**IMPERIAL METALS CORPORATION
MT. POLLEY PROJECT**

**RESPONSE TO REVIEW COMMENTS
ON TAILINGS EMBANKMENT DESIGN
(REF. NO. 1625/6)**

JANUARY 25, 1996

**TAILINGS STORAGE FACILITY
TAILINGS EMBANKMENT
SECTIONS AND DETAILS**

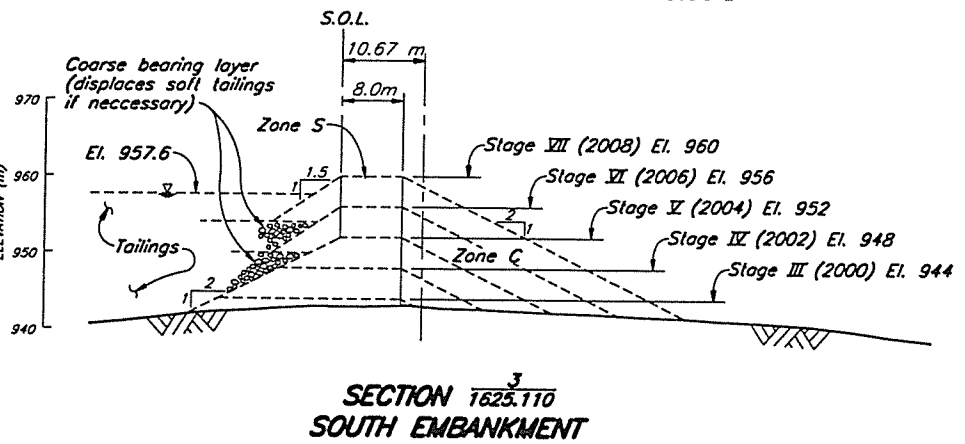
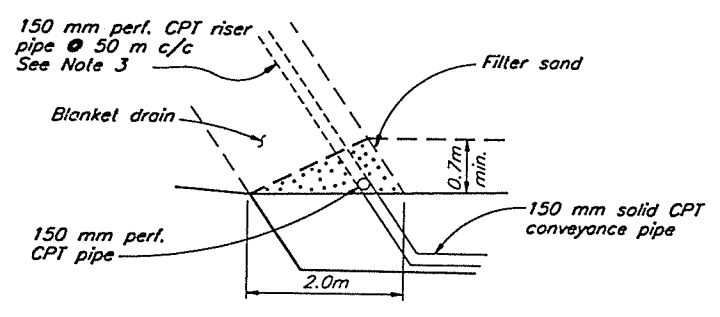
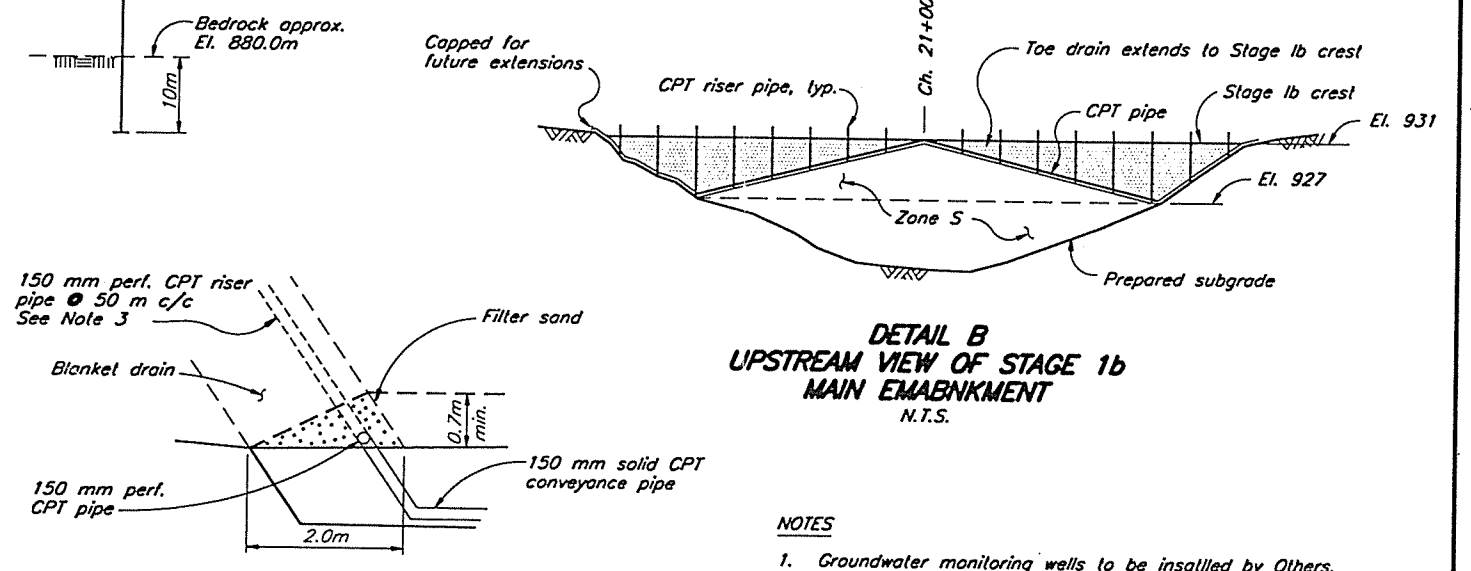
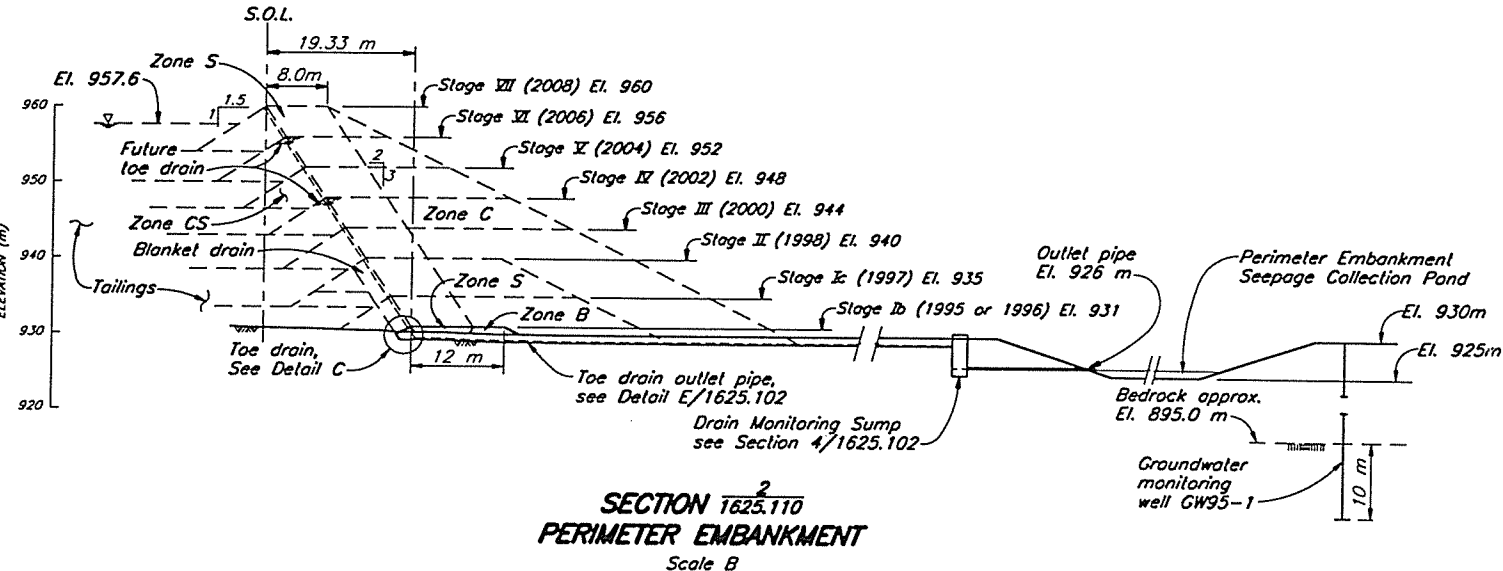
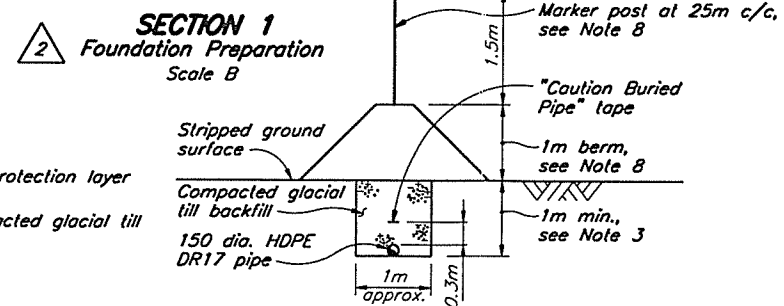
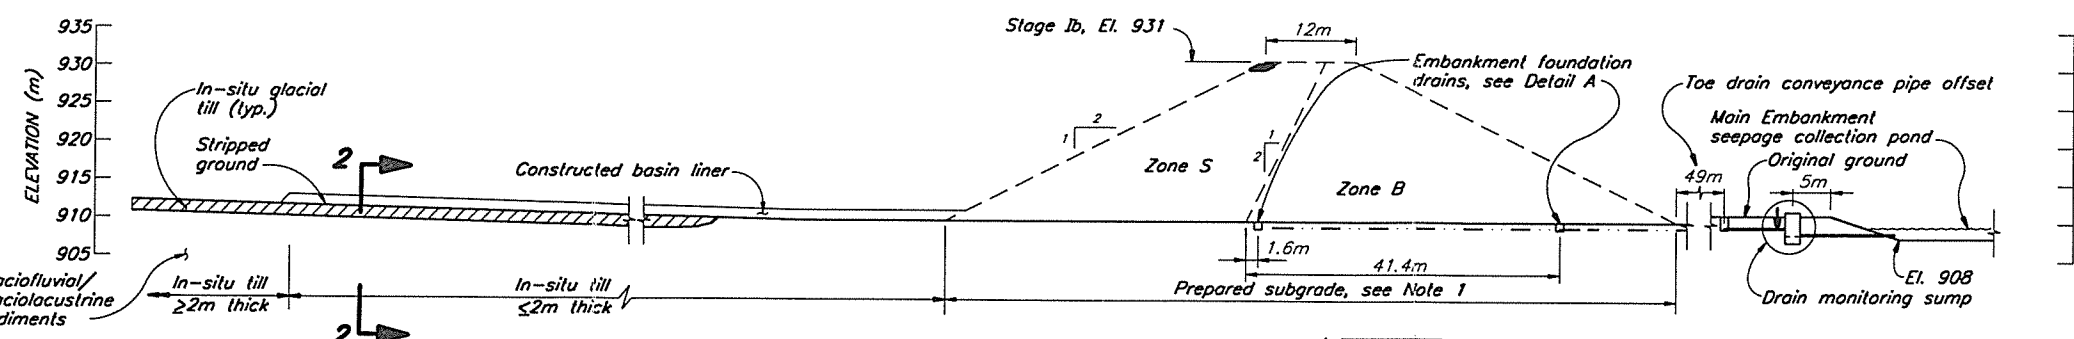
The design proposed entails some of the compacted main dam to be constructed over loose to medium dense tailings. With this design variability in consolidation characteristics would be expected. This could lead to tension cracks near the top of the main dam and generally parallel to C.L. Stability analysis should allow for 10 m deep tension cracks filled with water.

Vibratory compaction of the beach should also be considered for the beach zone in the zone downstream of the S.O.L. to ensure low compressibility results.

The modified centreline construction method is illustrated on Drawing 1625.111. As in the centreline construction method, the embankment fill zones extend onto the tailings beaches during each staged expansion. The tailings beaches will be comprised of sandy materials with a very high coefficient of consolidation. The compressibility of these materials will also be low and any settlements which result from on-going expansion of the embankment occur relatively rapidly and are complete during the construction period. In fact, one of the design requirements for each of the staged expansions on to the tailings beaches is for monitoring with vibrating wire piezometers in order to identify the development and dissipation of any excess pore pressures during construction. It has been our experience that any excess pore pressures which develop in the tailings tend to dissipate relatively quickly and the technical specifications include provisions for monitoring to ensure that the pore pressures have dissipated (and consolidation is therefore completed) prior to placement of each successive lift. Vibratory compaction of the first lift typically results in the largest pore pressure response in saturated tailings, after which successive lifts show progressively lower response to loading. The compressibility of the tailings decreases in response to the densification which results from loading and

compaction so that compression of the tailings during future staged expansions will not be significant.

IMPERIAL METALS CORPORATION	
MT. POLLEY PROJECT	
TAILINGS STORAGE FACILITY FOUNDATION PREPARATION AND BASIN LINER	
SECTION AND DETAILS

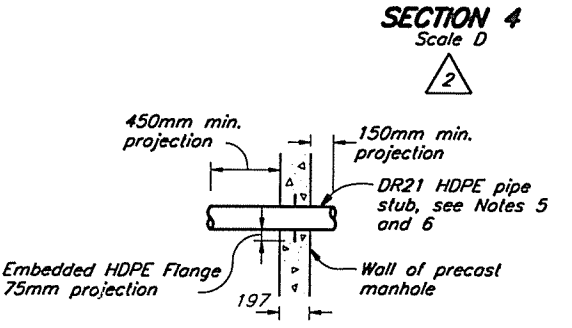
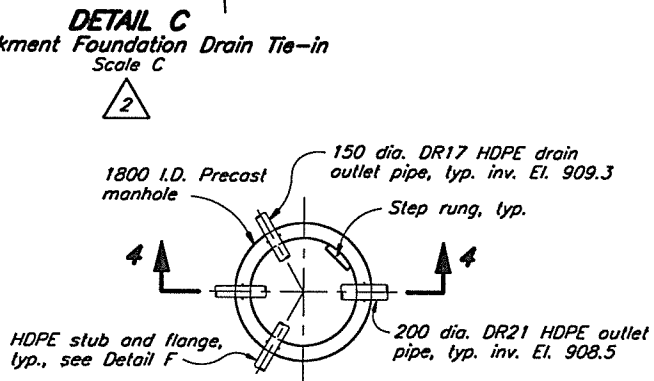
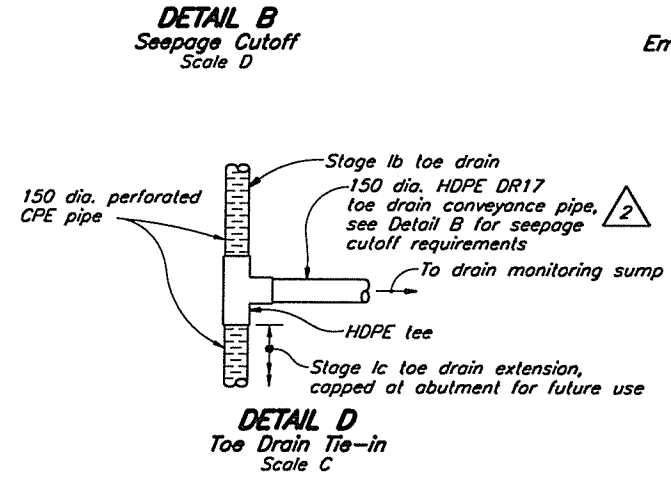
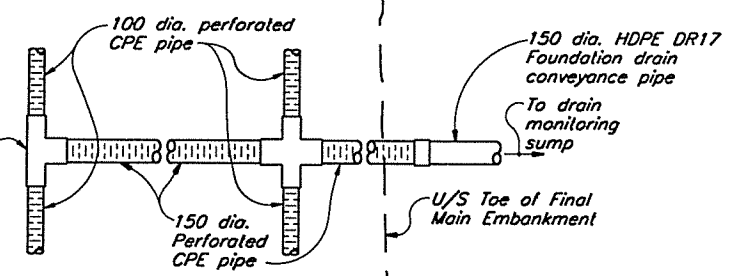
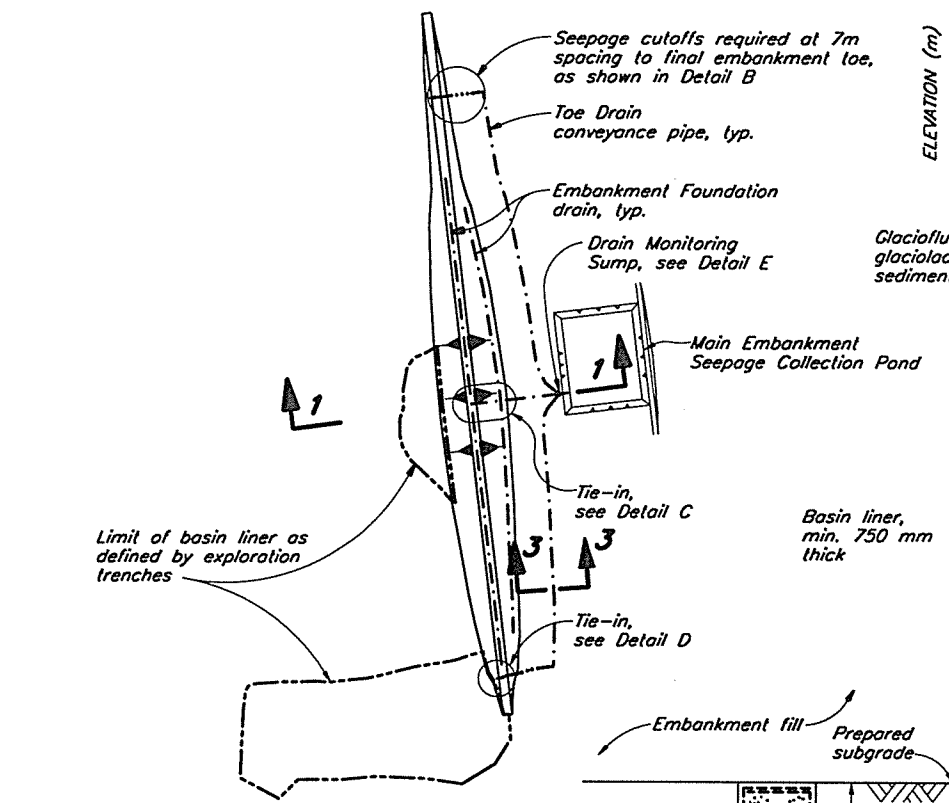
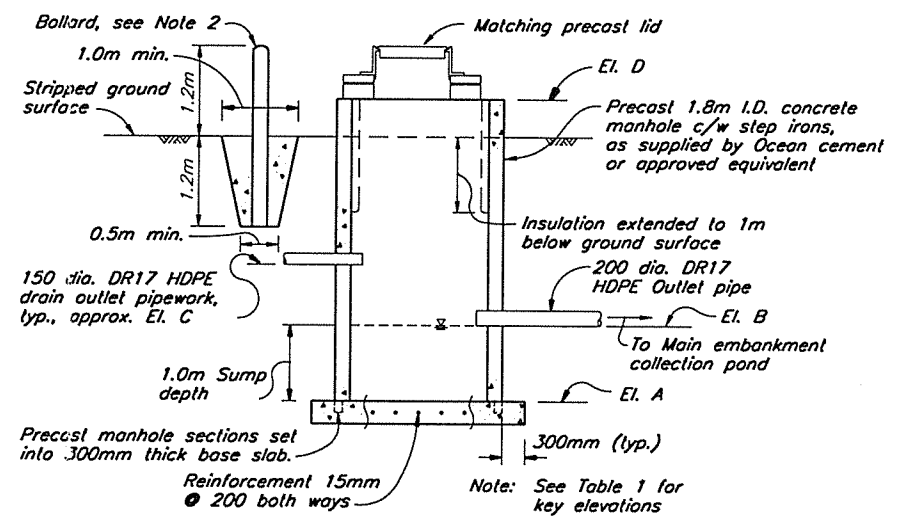
The design of all drain pipe must have sufficient strength to resist full earth load.

All drain lines that exit the dams must be designed so they can be cleaned for distances of about 100 m.

All culverts and drain lines must be designed or protected from icing up in the winter.

The design of the embankment drainage pipeworks is illustrated on Drawing No. 510-14-03-1625.202. The drainage pipeworks consist of CPE embankment foundation drains and DR17 HDPE pipework for the toe drains which pass through the

abutments at the Main Embankment. The perforated CPE foundation drains are not required to resist full earth loads as the drains include a gravel surround which provides contingency flow capacity. The HDPE toe drains pass below the core zone and have been designed to withstand full earth loads from the ultimate embankment. The HDPE drains could be cleaned out as recommended by Mr Brawner, and additional toe drains can also be installed during future embankment raises, if necessary.

A series of perforated CPE drain pipes surrounded by gravel and filter fabric were previously included for control of groundwater during construction of the partial basin liner and for long term monitoring. However, the additional site investigation test pits described above and in Appendix A, indicate that the extent of the constructed basin liner will be reduced and the comprehensive drainage network will not be required. Therefore, the basin groundwater drains have been removed from the current Detailed Design Drawings.

All embankment drainage pipes will be covered by a minimum of 1 m of soil to prevent freezing. Buried pipeworks downstream of the embankment also include a cover berm, both for protection from icing and for easy identification and location of the pipes. The outlet pipeworks discharge to a covered drainage sump prior to discharge below the water (or ice) surface of the seepage collection pond.

KNIGHT PIESOLD LIMITED CONSULTING ENGINEERS - VANCOUVER, B.C.	DESIGNED	KDE	IMPERIAL METALS CORPORATION MT. POLLEY PROJECT TAILINGS STORAGE FACILITY MATERIAL SPECIFICATIONS	
	DRAWN	RDT		
	CHECKED			
	APPROVED			
DATE	JUNE 2, 1995	SCALE AS SHOWN	DRG. NO. 510-14-03-1625.212	REV. 0

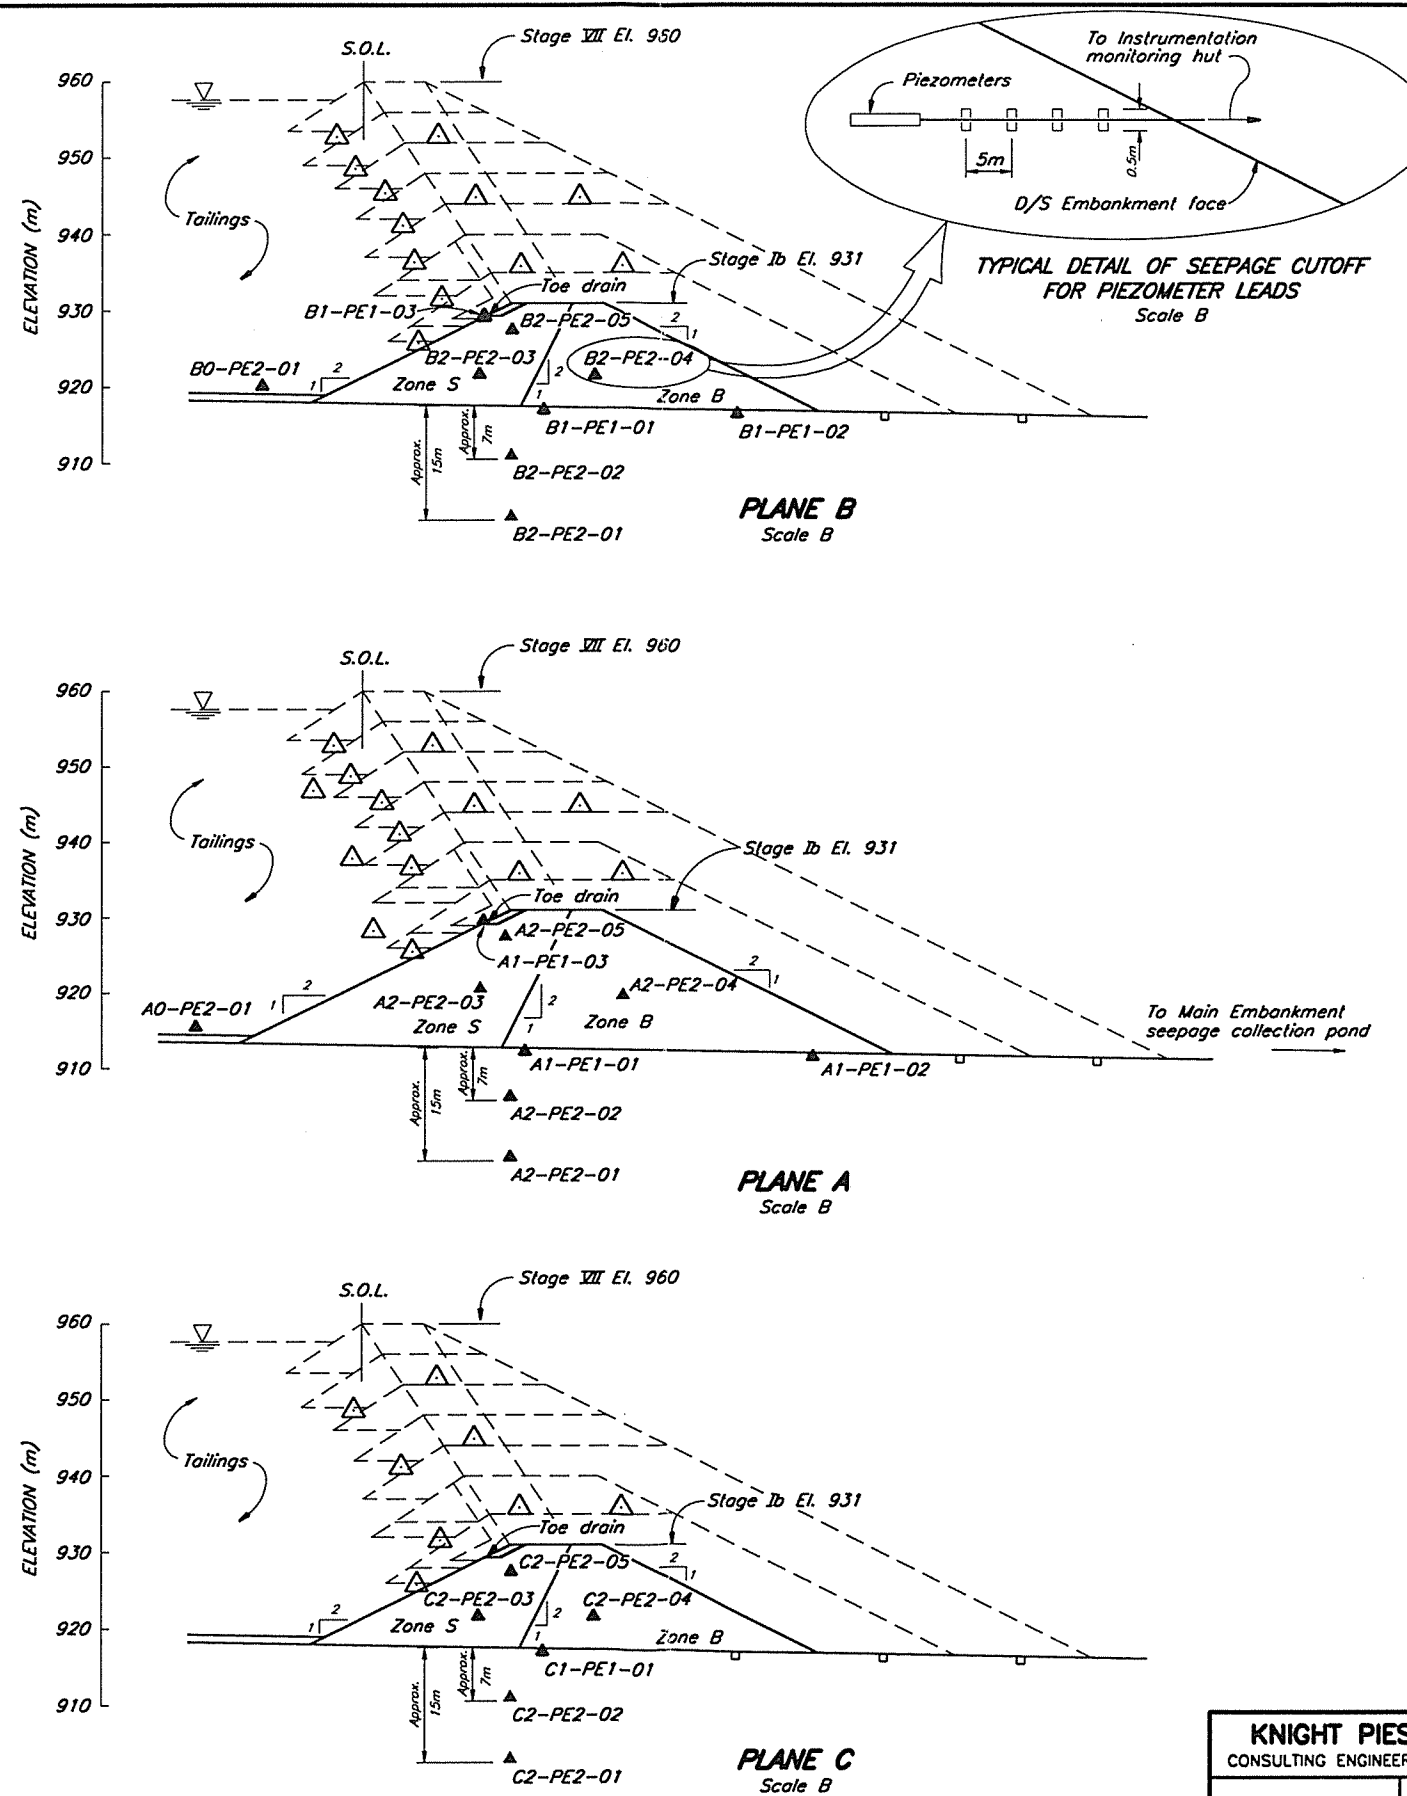
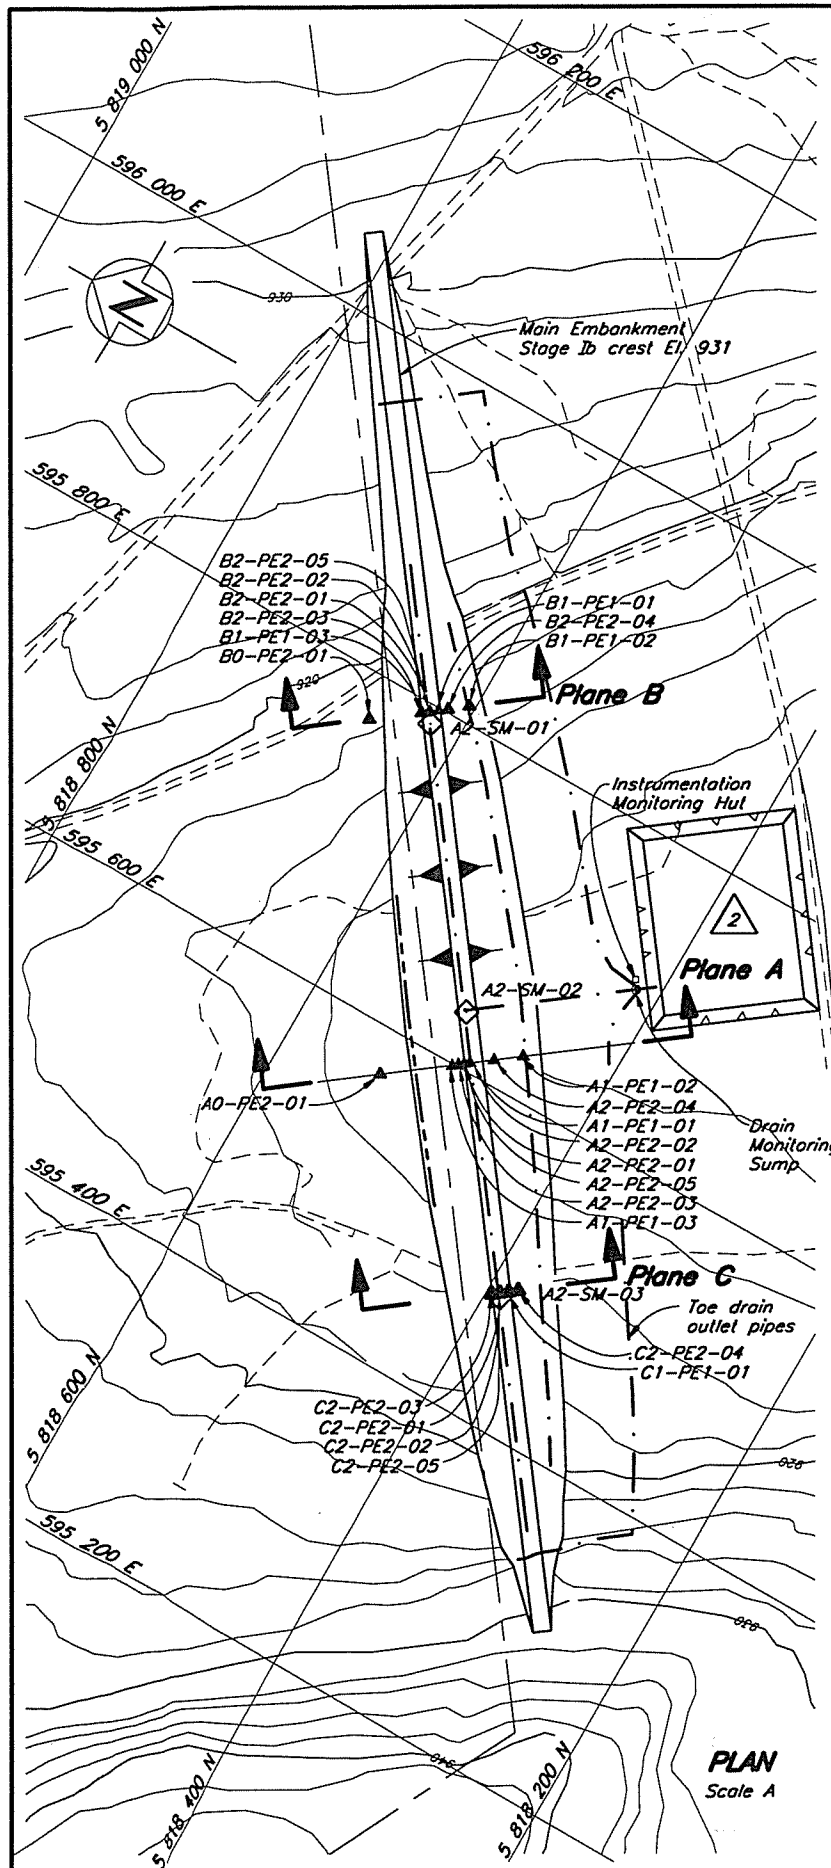
Filter gradation is required to be shown. The design must be conservative.

Provide the range of acceptable gradation.

Filter gradations for construction materials are shown on Drawing No. 510-14-03-1625.212, which is taken from part of the Technical Specifications. The gradation of the tailings is shown on Figure 1 (from Tailings Storage Facility Design Report, Ref. No. 1625/1, May 26, 1995).

Gradation envelopes for embankment fill materials are also included on Drawing No. 510-14-03-1625.212.
